767 Washington Street, NY

Re: LPC Comment  
767 Washington St.  
New York, NY 10014

**TSF No. 22188.00**

Our office is in receipt of the **Plan Review Comment** prepared by LPC and our responses to the comments on our Mechanical Engineering Plans are as follows:

Third Floor Plan - Exhaust Location Diagram  
Scale: 1/8" = 1'-0"

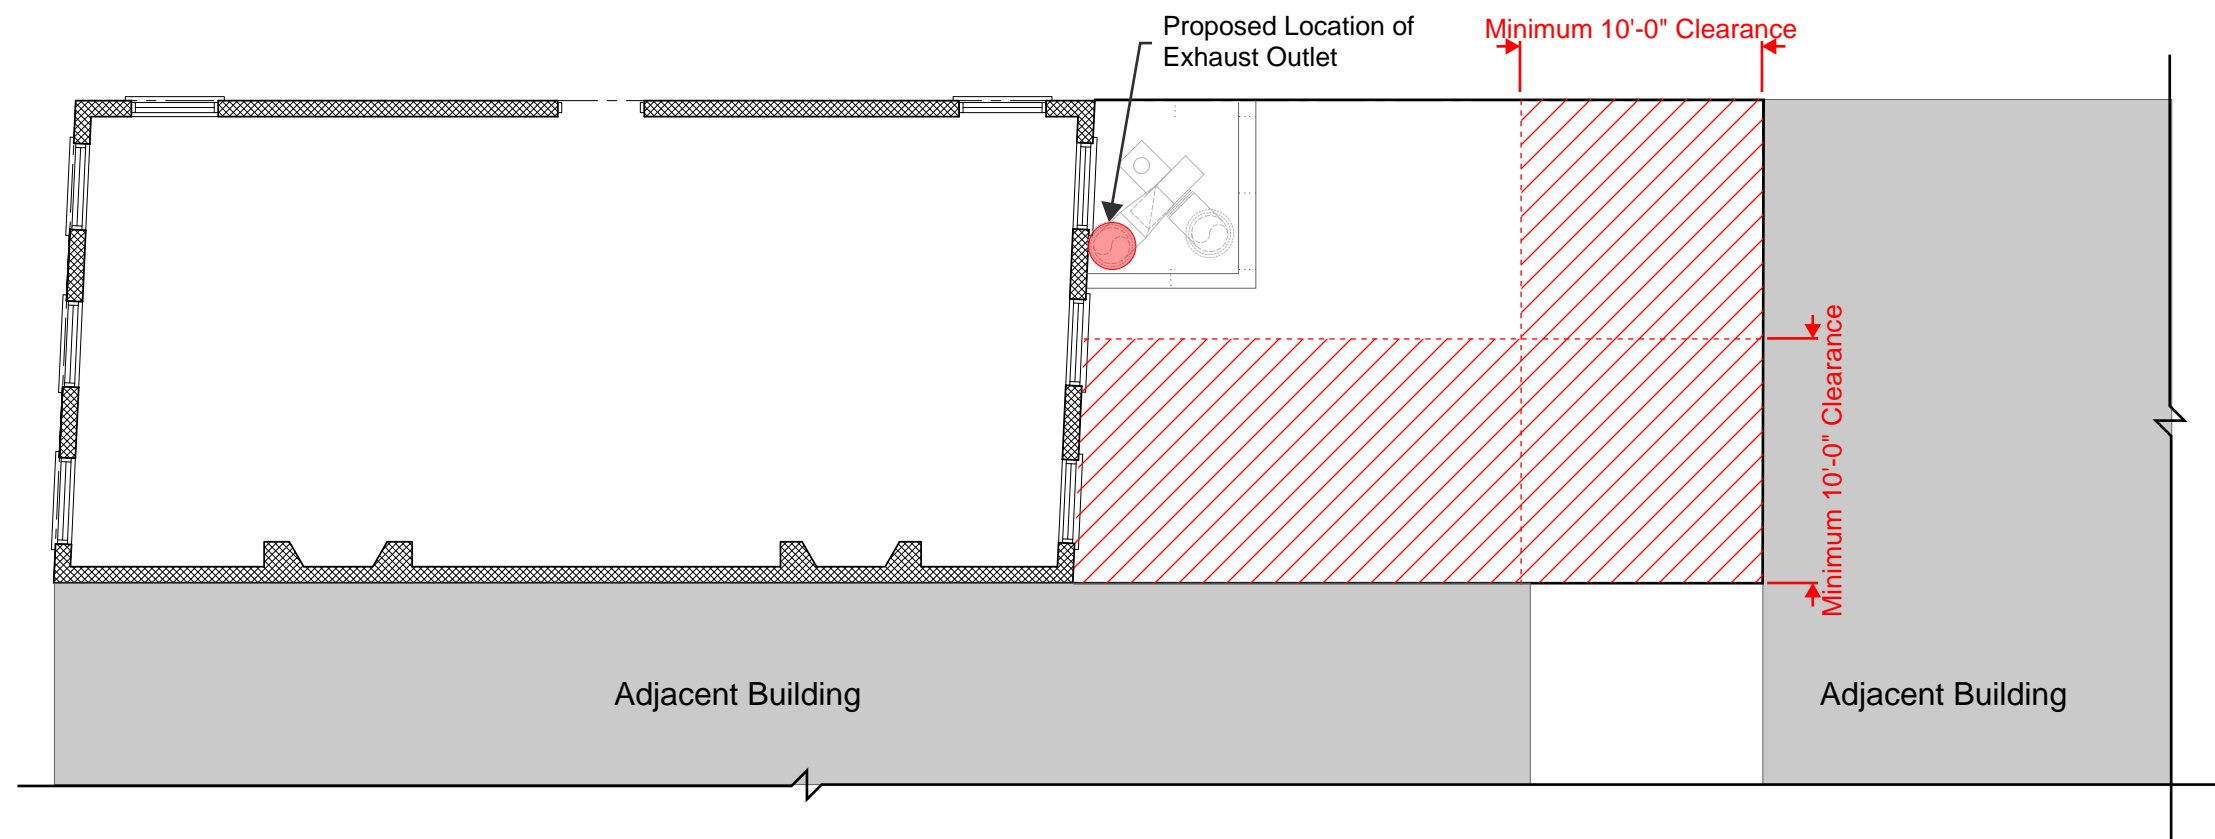
LPC is requesting a study of other locations and if we exhaustively tried to not locate it where it currently has been designed.

TSF Response:

We are required to maintain a minimum of 10 feet from any neighboring property lines, building walls, mechanical intakes and openings.

This restricts us to terminate in the currently utilized 10 feet by 18-foot section of space that happens to be nearest the street side of the building.

506.3.13.3 Termination Location

Exhaust outlets shall be located not less than 10 feet horizontally from parts of the same or contiguous buildings, adjacent buildings and adjacent property lines and shall be located not less than 10 feet above the adjoining grade level. Exhaust outlets shall be located not less than 10 feet horizontally from and not less than 3 feet above air intake openings into any building.
